Recall Campaign Bulletin

Campaign No. 2014120006, January 2015

SUBJECT: Models 212 Model Year 2015

Replace Second Row Double Seat Belt Buckle

Figure 1

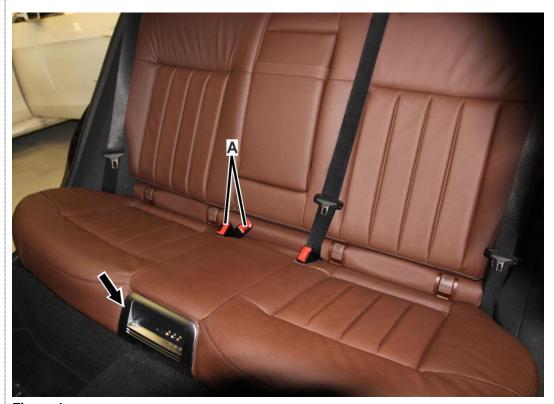
1. Replace double seat belt buckle (A, Figure 1) for right rear seat belt; refer to WIS: AR91.40-P-1516EW and perform steps 1, 3, 7.

- Note (regarding above WIS instructions)
- Disconnection of seat belt buckle switches does not apply to this campaign.
- Removal of circlip on seat belt buckle mounting bolt does not apply to this campaign.
- For vehicles with rear entertainment system, the paneling (arrow) on the DVD player must be removed prior to removing the rear seat; refer to WIS: AR82.60-P-7505-01EW.
- 2. Reassemble in reverse order.
